SERVICE BULLETIN

Rudder Centering Fork - Control Stop Replacement

SB-ASTM-CTLS-03

Model: CTLS

Fig. 1

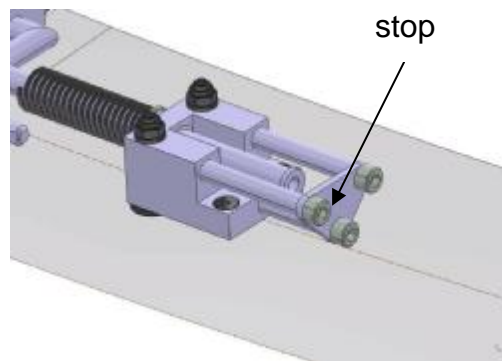
This is the rudder stop system that was installed to the CTLS affected by this SB ex factory. In this system the stop is provided to the rear end of the rudder centering fork, installed to the tunnel, below the instrument board. See following Fig. 1, 2 for illustration.

This system is the system affected by this SB.

Fig. 3

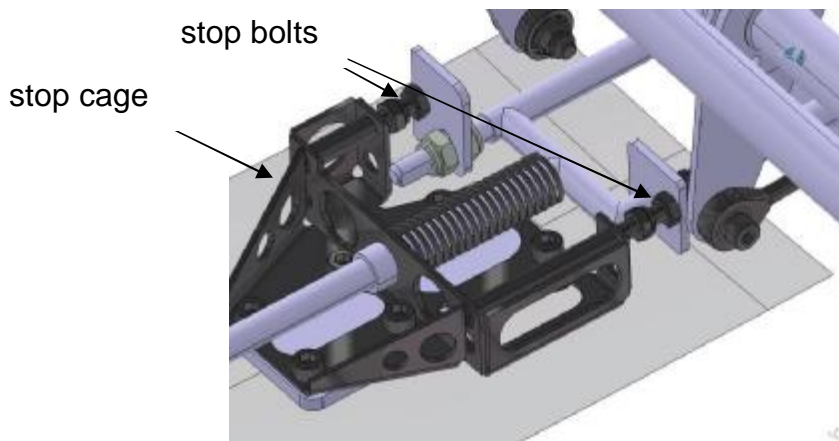
The new fork stop system provides a stop not to the rear end of the rudder centering fork, but to the thrust plates where the rudder centering fork contacts the bolt heads from the rudder pedal levers. The variant is clearly recognizable by the steel welded cage that provides the stops by means of adjustable bolts. See following Fig. 3 for illustration.

This stop device represents the valid type design and is used in serial production at the time of issuing of this SB. Only on aircrafts where the Rudder Stop Plates as by 3.1.3 cannot be used, this new fork stop system must be installed following this SB.

Fig. 10

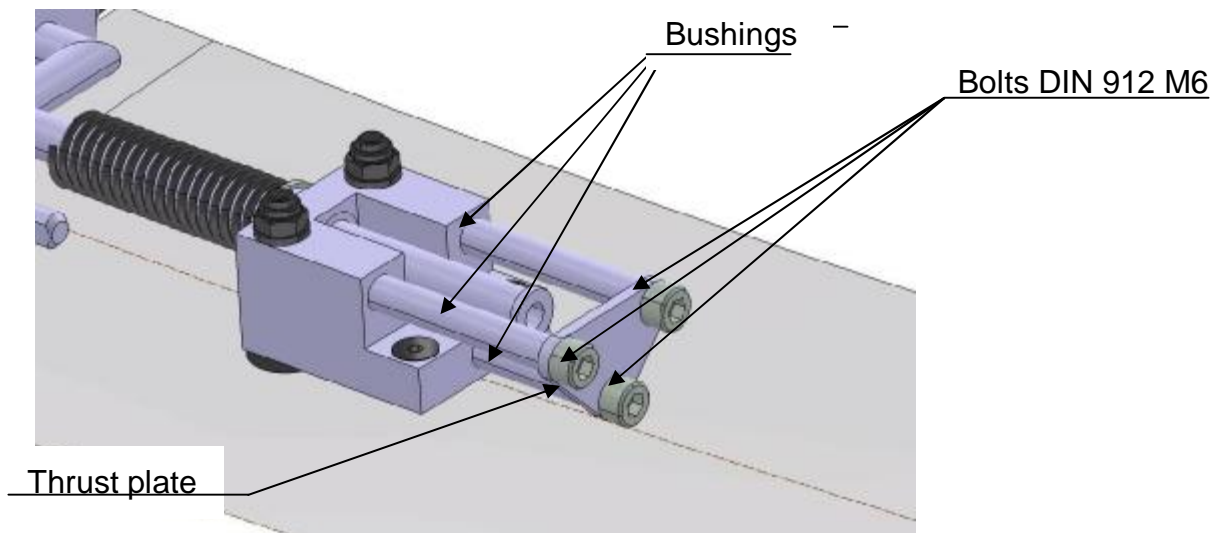
The old fork stop system, that guides the rear end of the rudder centering fork, must be uninstalled when the rudder stop plates are installed. To do this, remove the three bushings, bolts and thrust plate shown in Fig 10 from the fork mount block. Unscrew three (3) DIN 912 M6 bolts (Fig. 10). Discard these parts.

Fig. 11

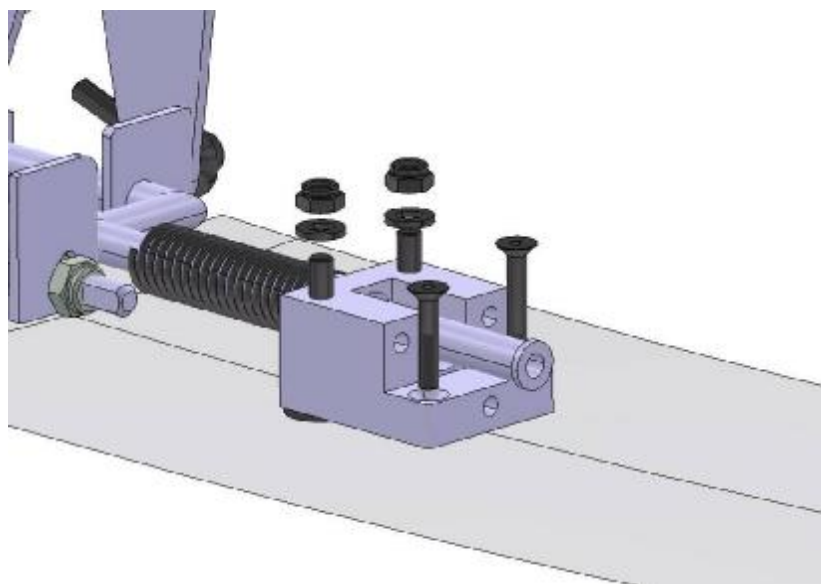
Remove the rear aluminum fork mount block from the lower fuselage skin by unscrewing the 4 bolts as shown in Fig. 11.

Warning: The spring installed to the rudder centering fork provides a pretension to the system and will push the aluminium block to the rear, once all bolts are removed.

Fig. 12

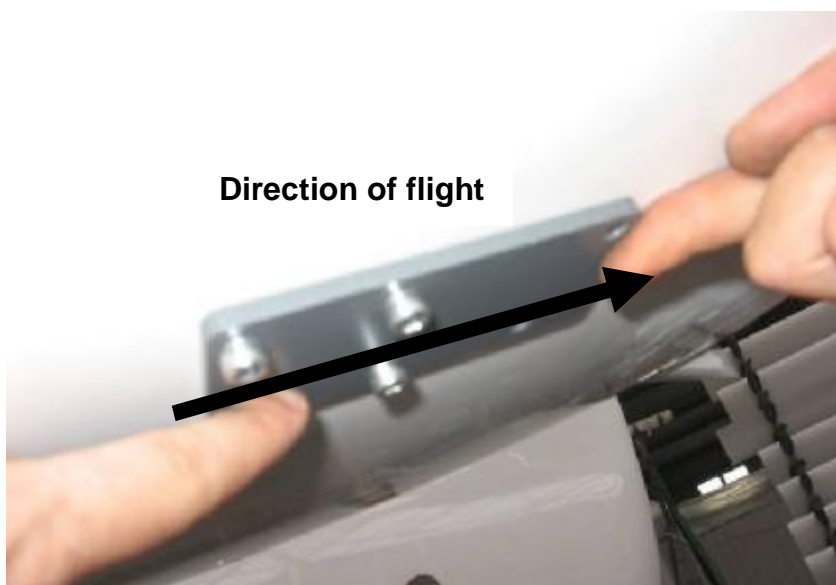
Bore out the four (4) existing holes from the outside bottom of fuselage to the new diameter Ø6mm.

Temporarily install PVC plate KF27200223 from the outside to the bottom fuselage using four (4) bolts (Fig. 12).

Warning: Installation must be exactly in the same position as the installation will be later on in the aircraft, so not turned upside down. When looking in direction of flight, the most forward hole on the left side must be rear of the most forward hole on the right side. Pay special attention, when drilling the holes you look from below In case of doubt use the new fork stop cage to cross check. See Fig 6.

Fig. 13

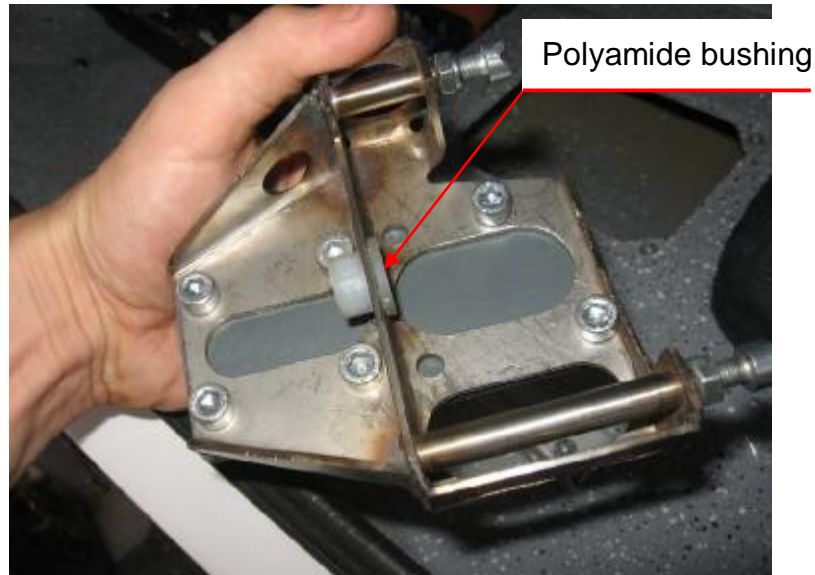
Remove polyamide bushing from the aluminum support that was uninstalled in step 3.3.3. Install this polyamide bushing to the guide hole of the new rudder stop device (Fig. 13).

Take the new fork stop system cage and place the PVC plate on the lower side and insert the 6 attachment bolts (Fig 13).

Fig. 16

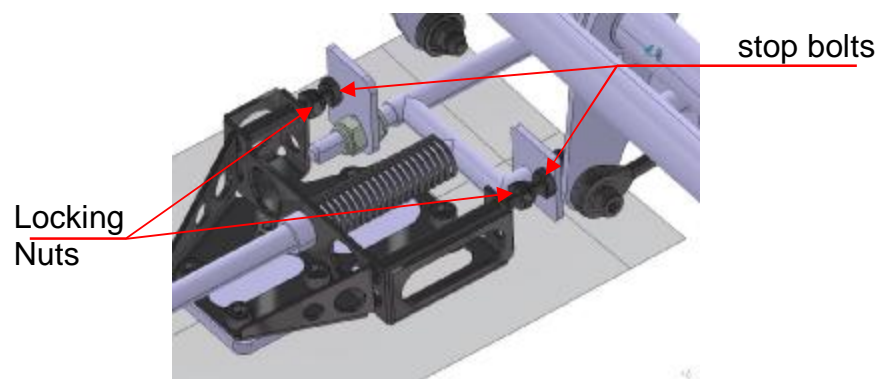
Adjustment of the rudder stops is achieved by changing the length of the stop bolts, inserted to the new fork stop system cage (Fig. 16). When deflected, the fork plates are pushed against these stop bolts. Changing both of the bolts allows increasing or decreasing the maximum rudder deflection.

Warning: The stops on both sides of the new system must be installed so that the stop at the side where the pedal is deflected touches the centering fork first or at the same time as the other side does. The opposite stop from the deflected pedal cannot touch first.

After finishing of the adjustment tighten the locking nuts (Fig 16) on the stop bolts.

Fig. 17

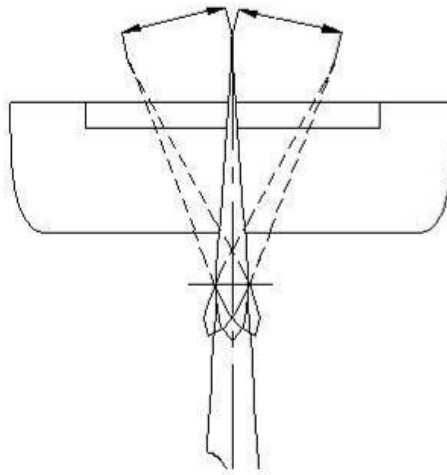
Maximum rudder deflection is measured at the lower trailing edge of the rudder as shown in Fig 17.

206-228mm (8-9 in)
